## STAFF RECOMMENDATION 1305 Gallatin Avenue September 17, 2014

**Application:** Partial demolition; New construction—addition; Setback determination  
**District:** Eastwood Neighborhood Conservation Zoning Overlay  
**Council District:** 06  
**Map and Parcel Number:** 07213040900  
**Applicant:** Jeffrey Stahl  
**Project Lead:** Melissa Baldock, melissa.baldock@nashville.gov

<p><b>Description of Project:</b> Application is to alter and construct an addition to a non-contributing commercial structure. The project requires a setback determination.</p>	<p><b>Attachments</b> <b>A:</b> Site Plan <b>B:</b> Elevations</p>
<p><b>Recommendation Summary:</b> Staff recommends approval of the project with condition that staff approve a brick sample, and the location of the HVAC units and other utilities. With this condition, staff finds that the project meets Sections II.B.1., II.B.2., and III.B.2. of the <i>Eastwood Neighborhood Conservation Zoning Overlay: Handbook and Design Guidelines</i>.</p>

Figure 4. The site plan shows the outline of the existing structure and the new additions. Note that the area circled is an un-covered and un-enclosed pad that is not considered when determining the setback.

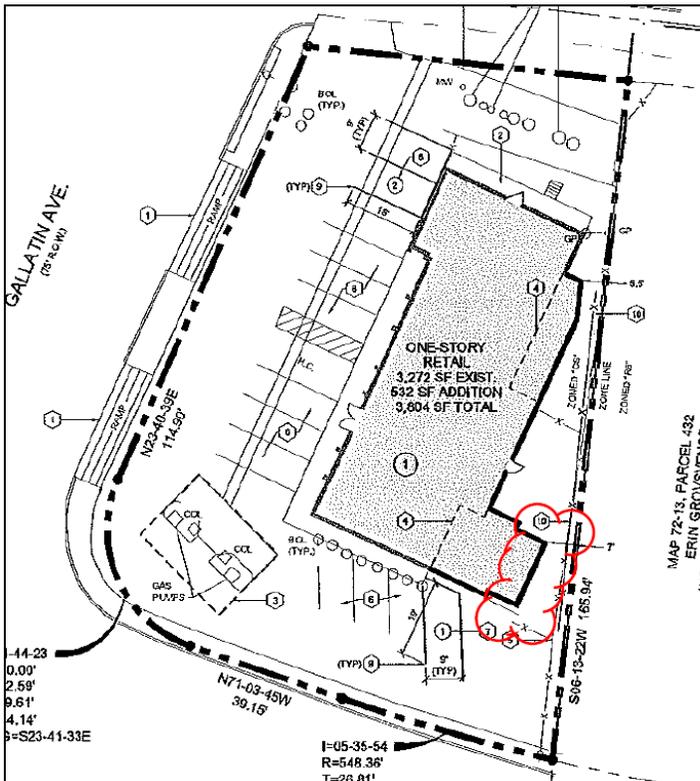
The existing commercial structure currently does not meet the existing twenty foot (20') rear setback, and additions to the rear will further encroach upon the setback (Figure 4). At their closest point, the new additions will be five feet, six inches (5'6") from the rear property line. This is about two feet (2') closer than the closest point of the existing structure to the rear property line. Towards Douglas Avenue, where the rear property is closest to the left façade of the house at 1107 Douglas Avenue, the addition will be approximately twelve feet (12') from the rear property line at its closest point. Because of the angle of the building, only a portion of it will encroach into the setback area, rather than the entire width of the building.

Staff finds the proposed setback determination to be appropriate in this instance because the existing structure does not meet the required rear setback, and the expanded structure will only sit a few feet closer to the rear property line than what is existing. MHZC staff spoke to the staff at the Codes Department, and the Codes department agrees with the proposed rear setback because there is “no increase in the degree of non-conformity.” Staff therefore finds that the project meets Section II.B.1.c. and II.B.2. of the *Eastwood Neighborhood Conservation Zoning Overlay: Handbook and Design Guidelines*.

Site Plan  
**C-2.1**

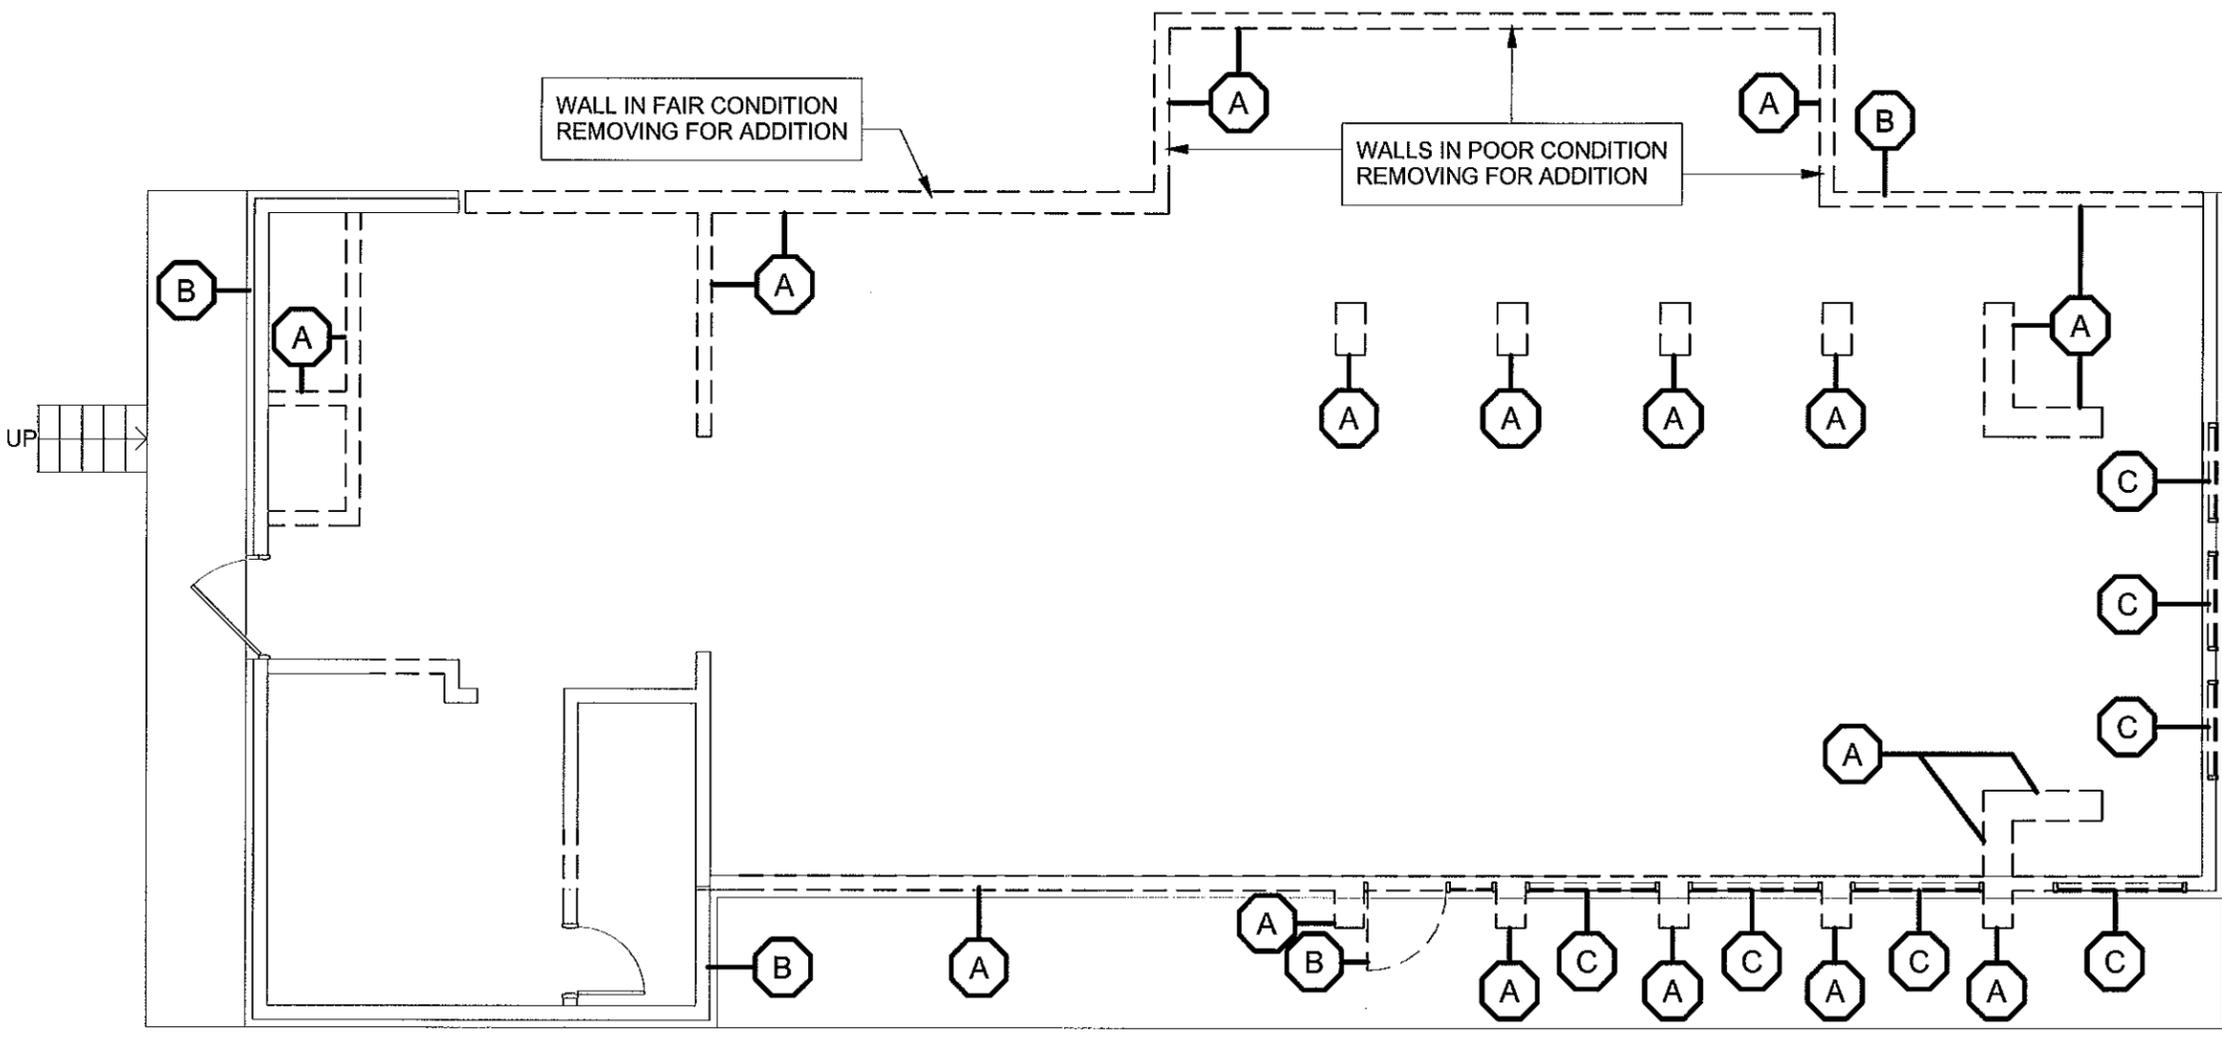
MHZA Note: this area is an uncovered, and un-enclosed concrete pad
